NUCLEAR ENERGY SERVICES, INC.

ISI FIELD CHANGE AUTHORIZATION

Document Title NOZZLE SAFE ENDS

Document No. 80A0475 Rev. 6

FIGURE 10 ULTRASONIC EXAMINATION PROCEDURE FOR CORE SPRAY SAFE END WELDS (CAL BLOCK CS-1-1A, CS-1-1B, CS-2-A, CS-2-B)

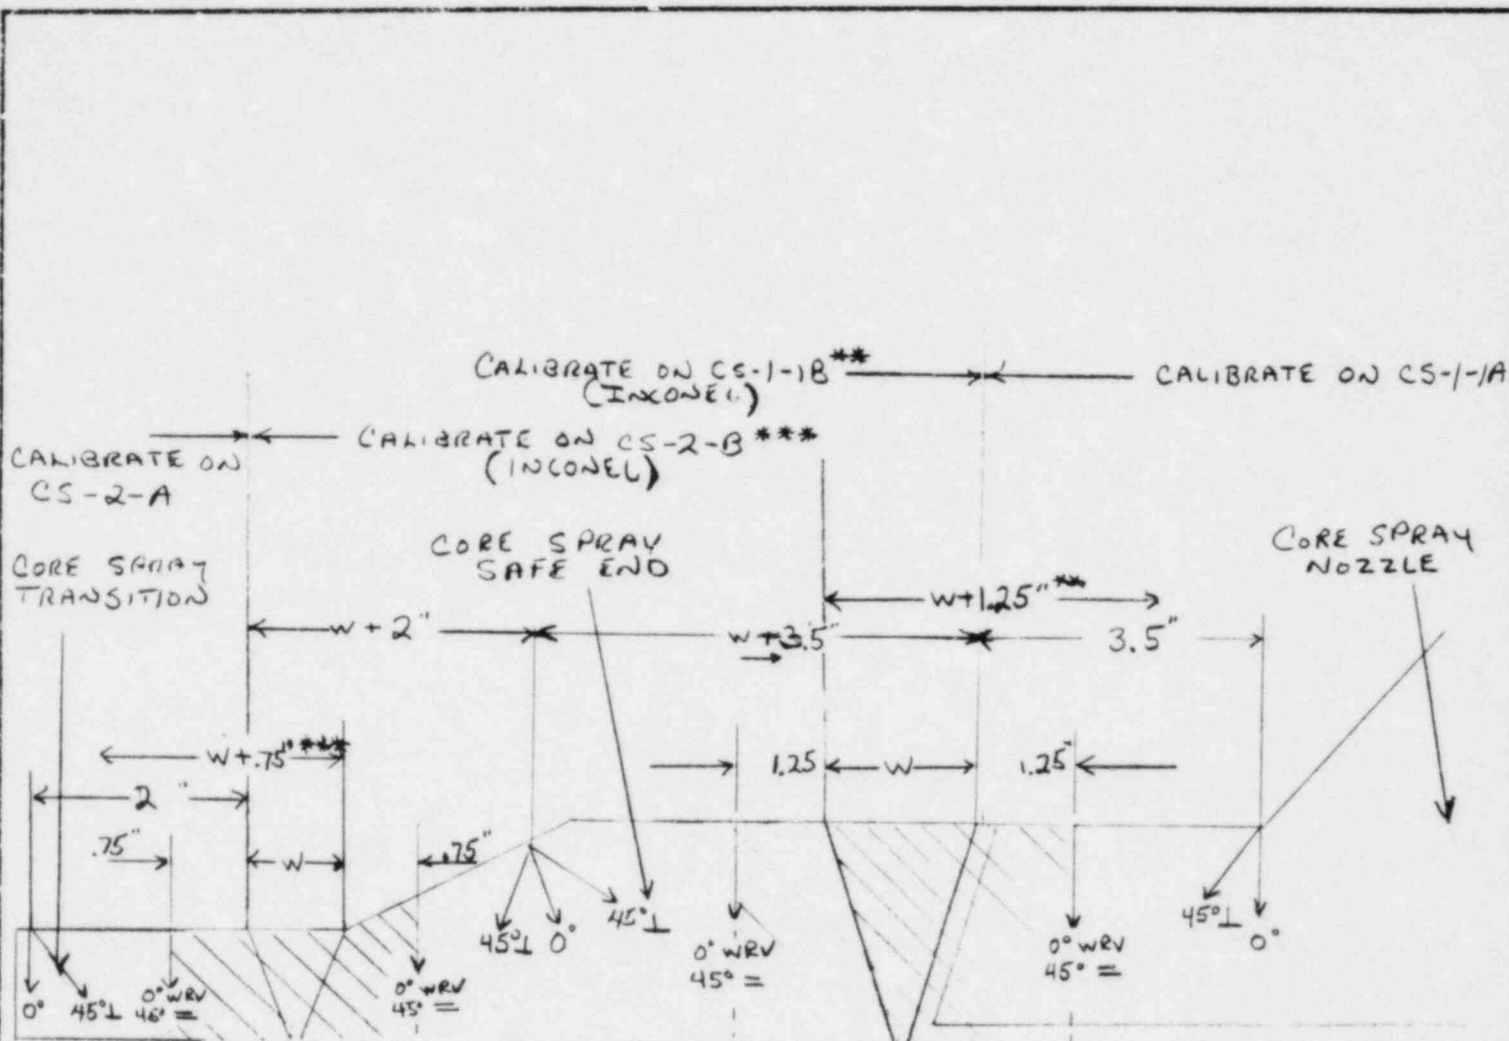
- ① ADD FIGURE 10 ULTRASONIC EXAMINATION PROCEDURE FOR CORE SPRAY NOZZLE TO SAFE END PIECE AND SAFE END PIECE TO TRANSITION PIECE WELDS. CAL BLOCKS CS-1-1A, CS-1-1B, CS-2-A, CS-2-B
- ② CHANGE PARAGRAPH 1.4.1, 1.4.2, AND 1.5 TO READ ... FIGURE 1 THROUGH 10.

TO INCORPORATE NEW CAL BLOCKS & PROCEDURES FOR CORE SPRAY SAFE END WELDS.

Figure 2 - Ultrasonic Examination Procedures for Jet Pump Instrumentation (N8) Nozzle to Safeend Welds, Cal. Block "JP1"

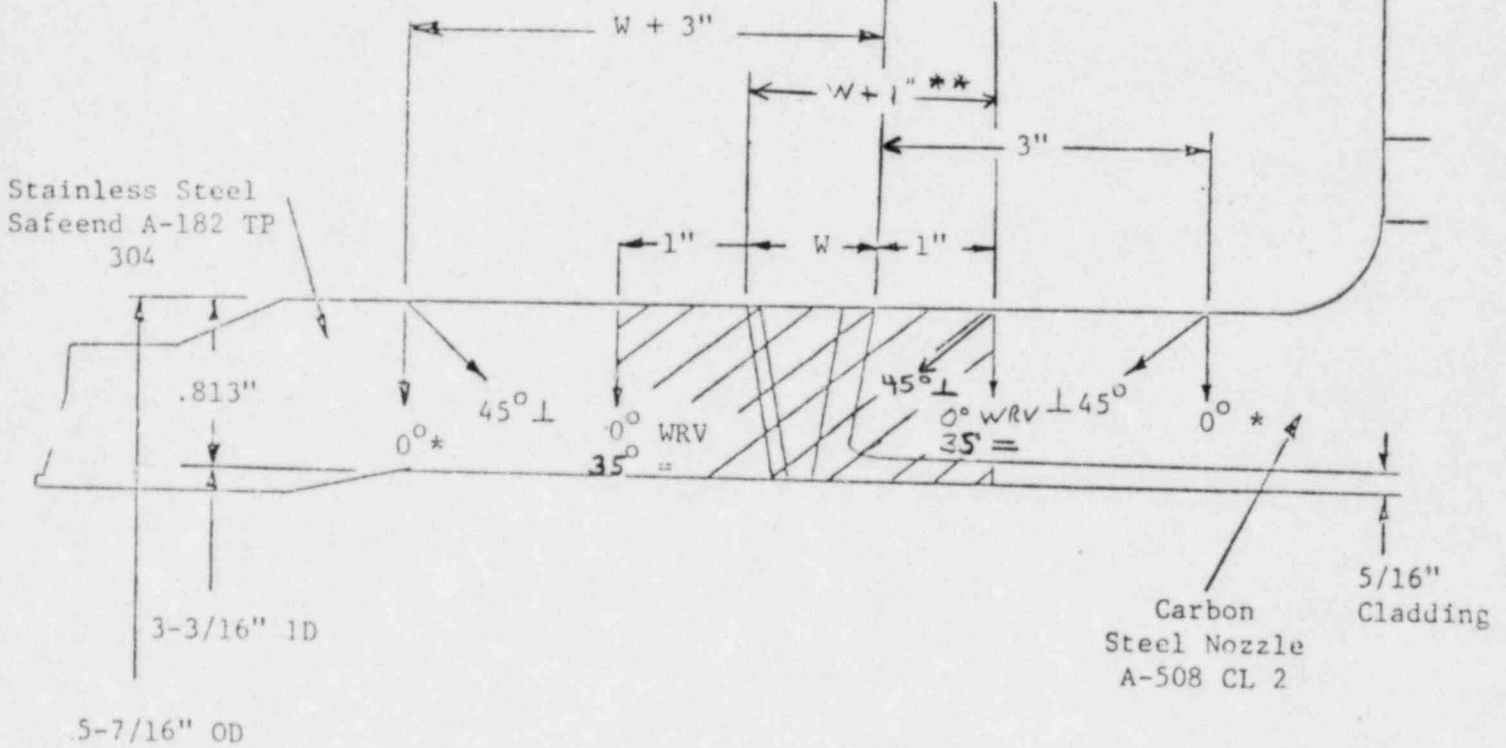
- ① PARA. 5.2.3 CHANGE "NOTE" TO READ .... UTILIZE A 35° ANGLE BEAM TECHNIQUE AND 1/2 VEE CALIBRATION.
- ② CHANGE FIGURES 2, 3, 8, AND 9 TO SHOW SCANNING PROCEDURE & COVERAGE FOR BIMETALLIC SAFE END WELDS IN ACCORDANCE WITH FC-1.
- ③ CHANGE 30° = SCAN ANGLE TO 35° = ON FIGURES 2, 5, AND 6.

- ① TO ALLOW FOR A USABLE CALIBRATION WHERE T/D RATIOS EXCEED .15
- ② TO ILLUSTRATE SCANNING TECHNIQUE AND SCAN PATHS IN ACCORDANCE WITH FC-1
- ③ TO CONFORM WITH PARA. 1.2.1 AND 5.2.3 OF THE PROCEDURE.
